## ADDENDUM #1

Reference: HVAC Upgrades – Building C – Davis ATC  
Utah College of Applied Technology – Kaysville, Utah  
DFCM Project No. 07174220

Project Name: Davis ATC HVAC Upgrade Building C

Addendum No.: 1

**A2 MECHANICAL ROOF PLAN**  
SCALE: 1/32" = 1'-0"

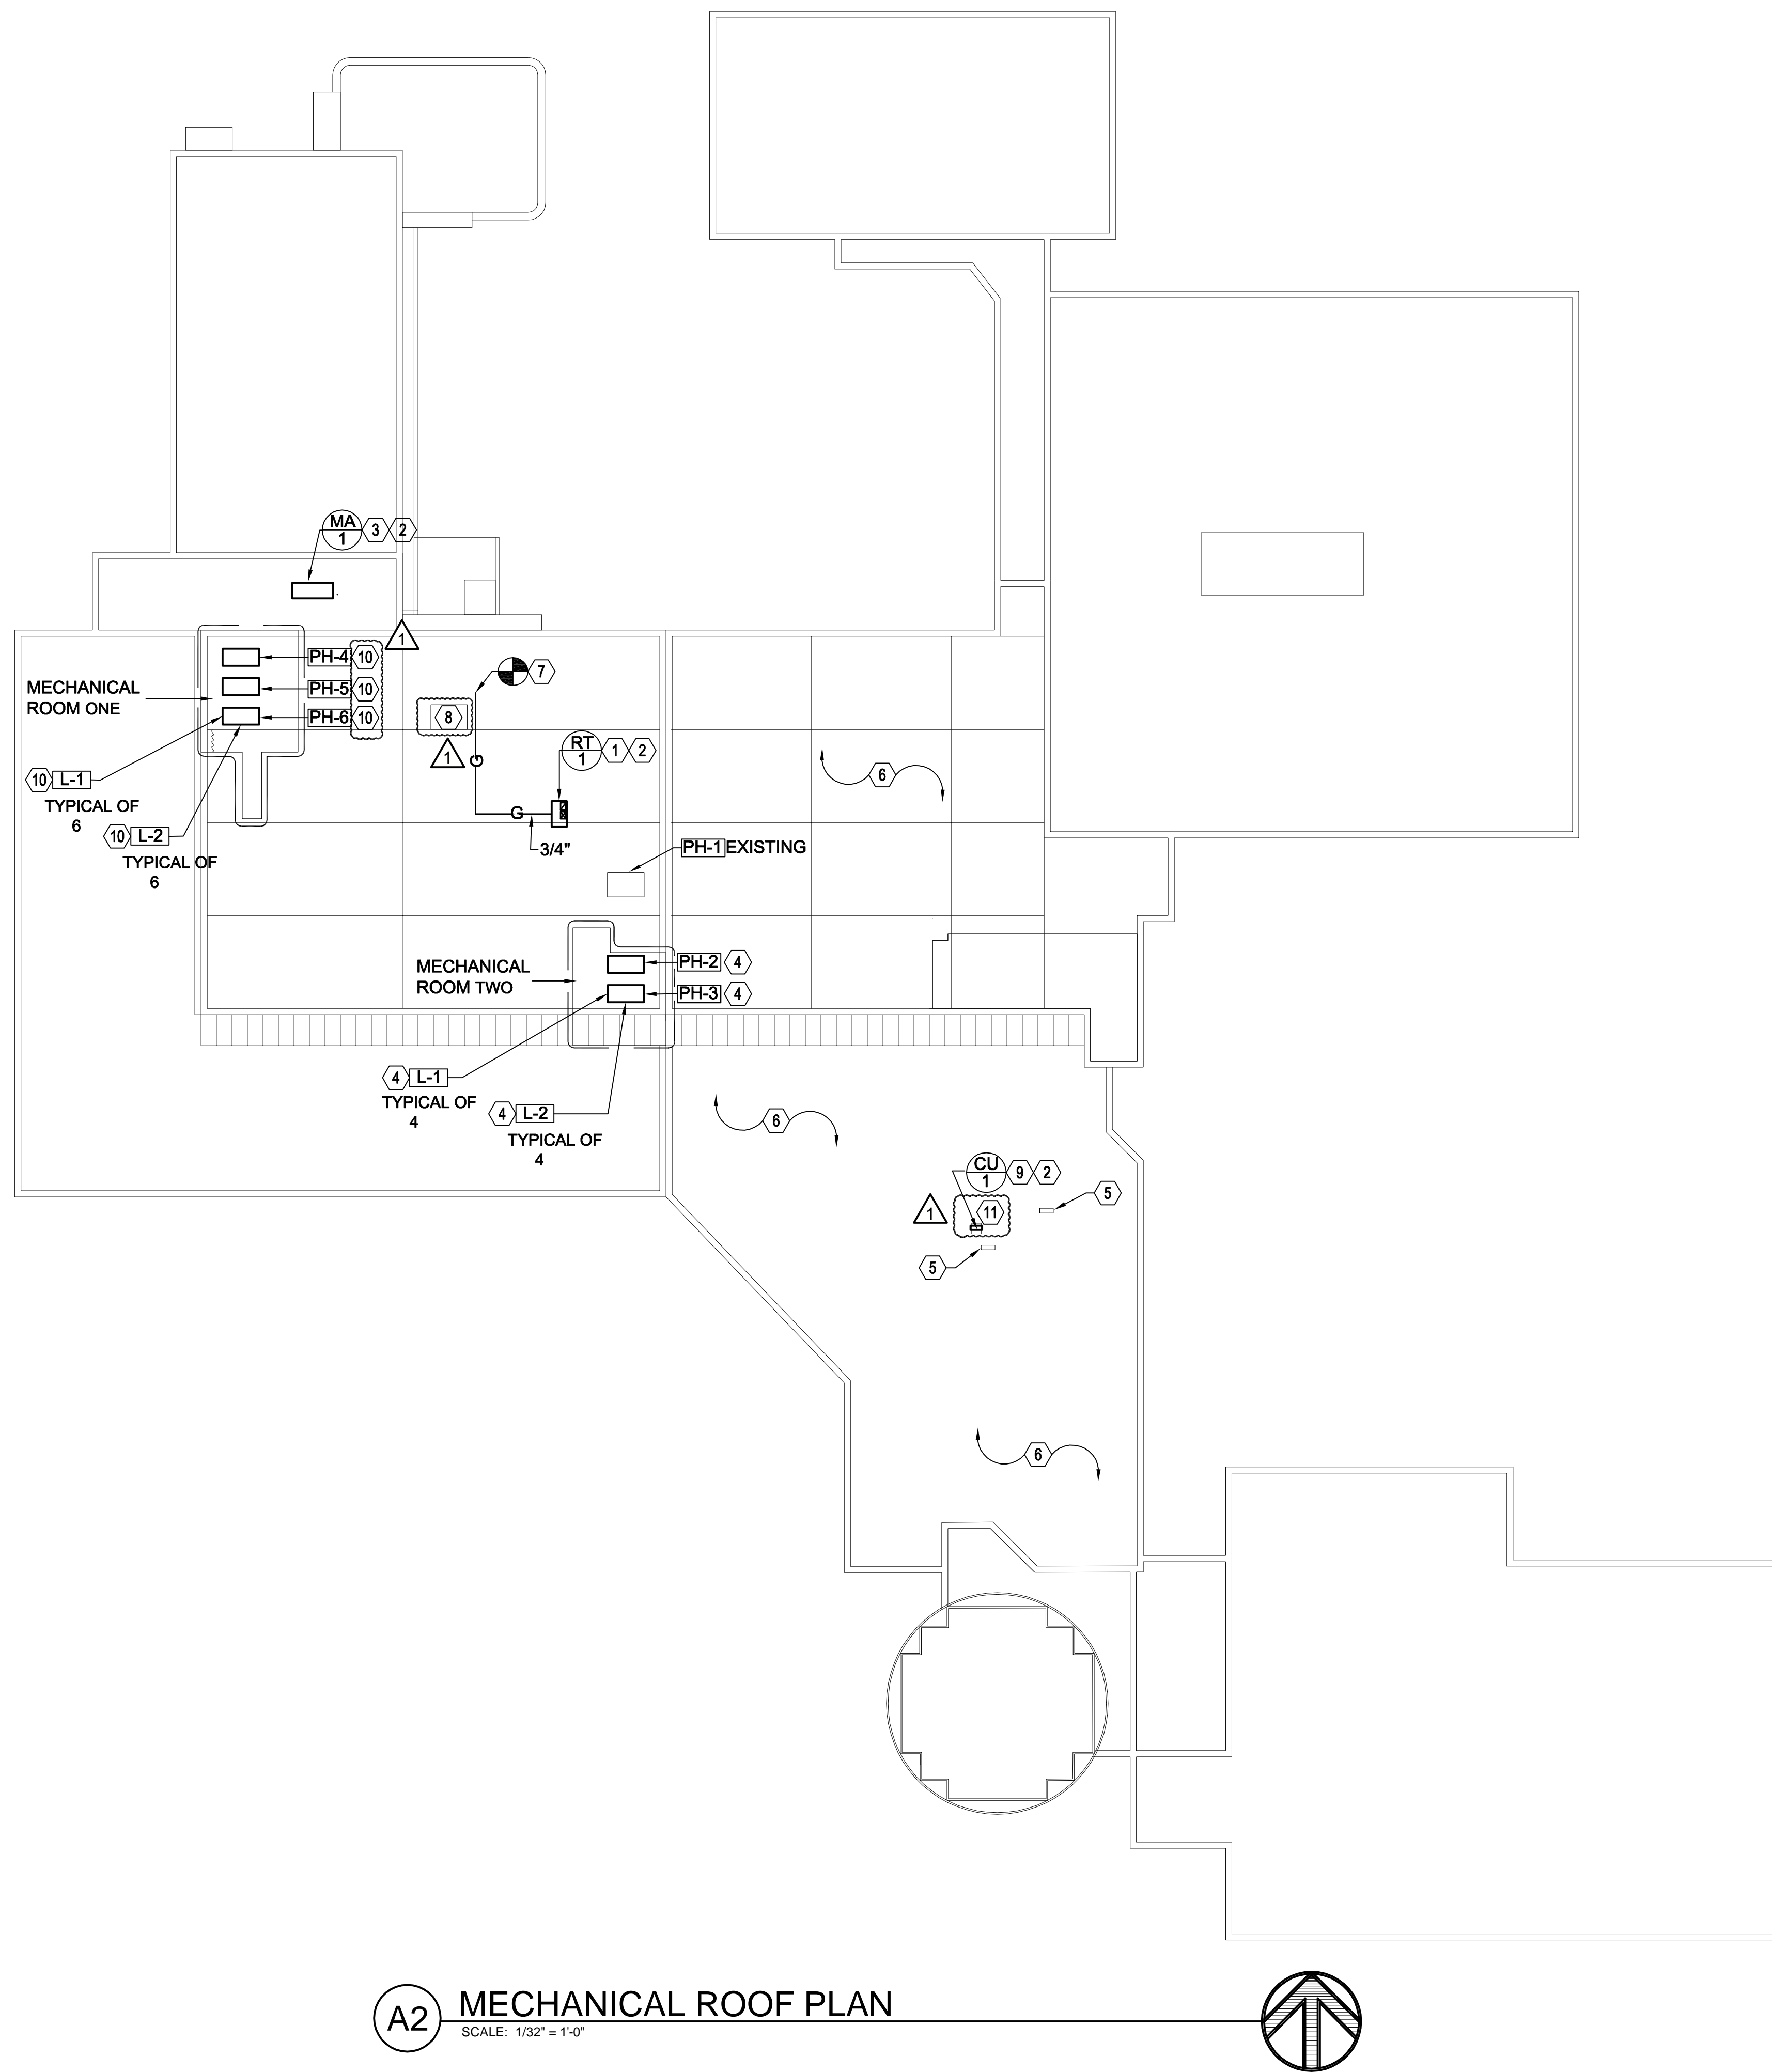
Item VI-1. ME101A Remove existing condensing unit not in use. Coordinate with DATC to relocate antennas. Re-use existing curb for new CU-1. See attached sheet.

Item VI-2. ME101A Base bid to remove weather hoods. Alternate #1 replace louvers for penthouses 2,3. Alternate #2 replace louvers for penthouses 4,5,6. See attached sheet.

- ④ BASE BID: REMOVE EXISTING WEATHER HOOD AT EXISTING ROOF MOUNTED PENTHOUSE UNITS. ADDITIVE ALTERNATE #1: REPLACE EXISTING LOUVERS AT TWO (2) EXISTING ROOF MOUNTED PENTHOUSES. FIELD VERIFY EXACT LOUVER DIMENSIONS BEFORE ORDERING. SEE DETAIL A2/ME502.

- ⑩ BASE BID: REMOVE EXISTING WEATHER HOOD AT EXISTING ROOF MOUNTED PENTHOUSE UNITS. ADDITIVE ALTERNATE #2: REPLACE EXISTING LOUVERS AT THREE (3) EXISTING ROOF MOUNTED PENTHOUSES. FIELD VERIFY EXACT LOUVER DIMENSIONS BEFORE ORDERING. SEE DETAIL A2/ME502.

- ⑪ REUSE EXISTING CURB FOR NEW CU-1 AFTER REMOVING EXISTING CONDENSING UNIT THAT IS NO LONGER IN USE. COORDINATE WITH DATC TO RELOCATE ANTENNAS.

**C1 GAS SUPPORT ON ROOF DETAIL**  
SCALE: NONE

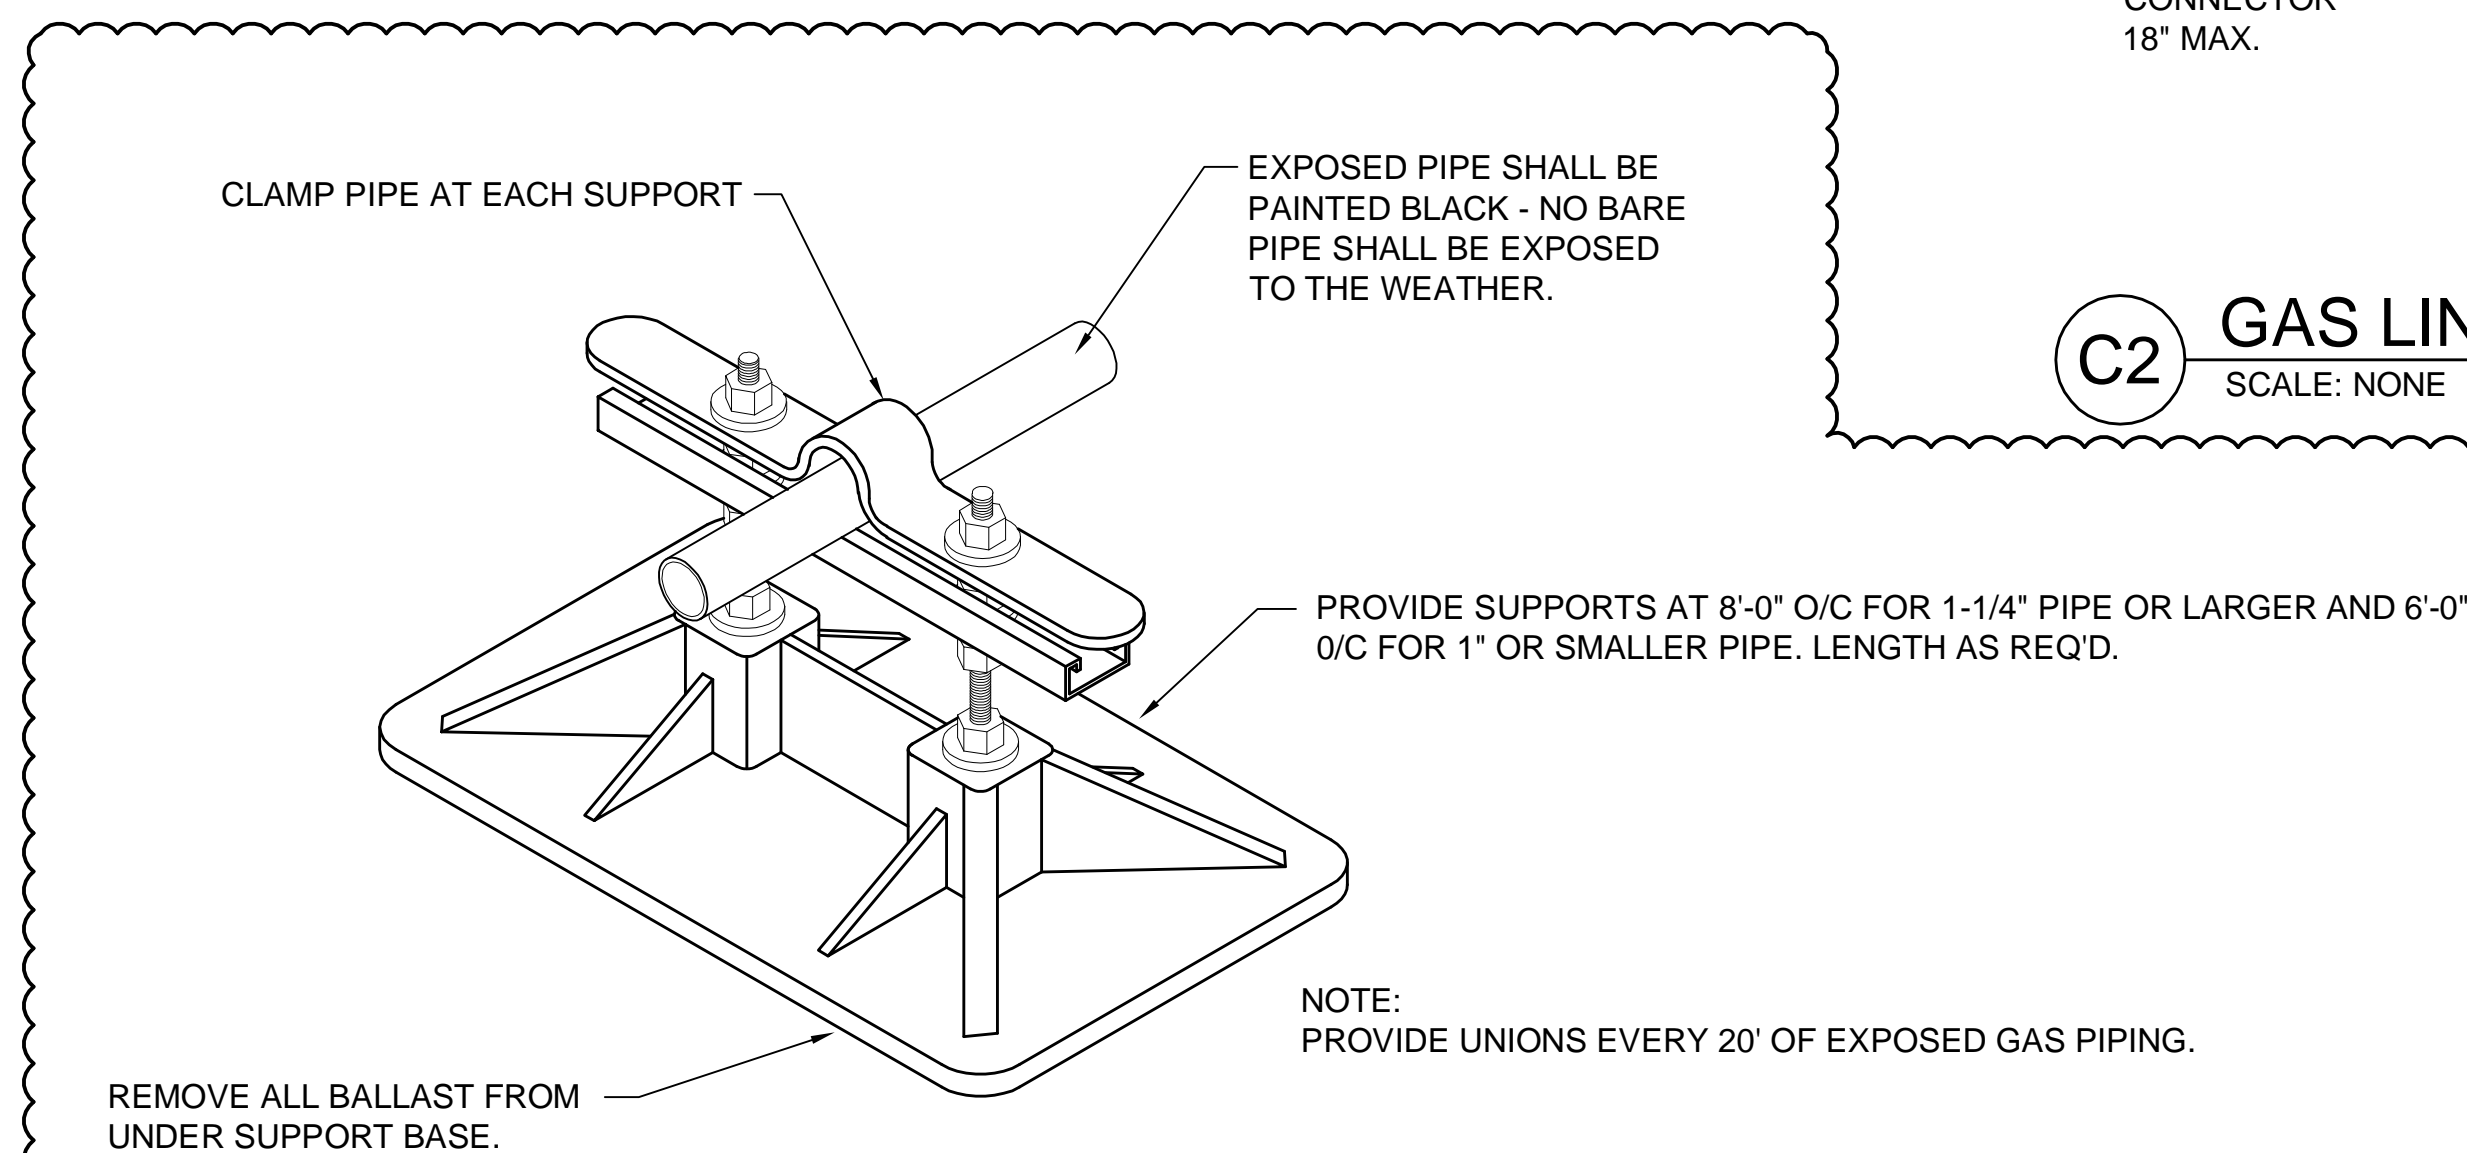
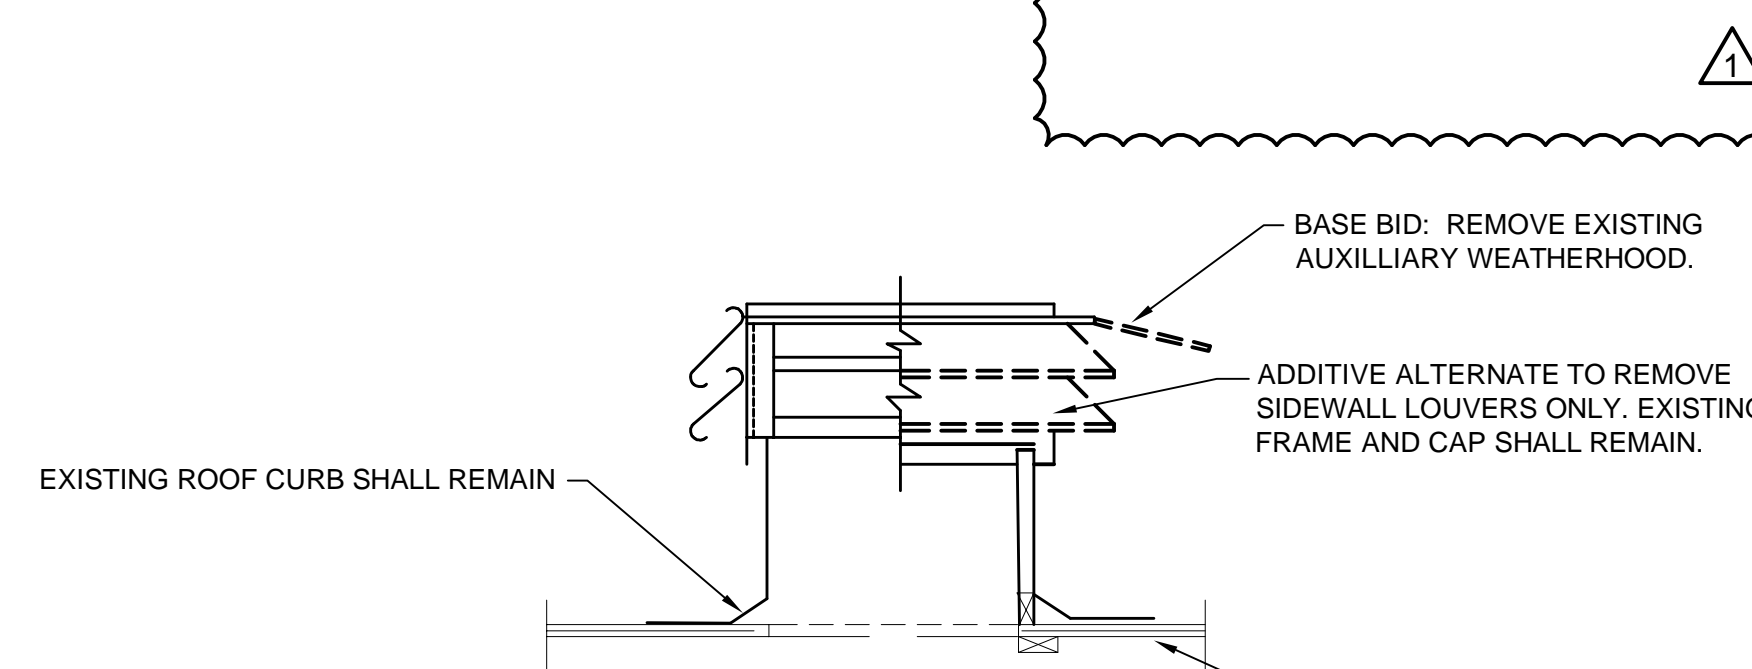
Item VI-3. ME501A see attached revised sheet with gas pipe roof support and penthouse details.
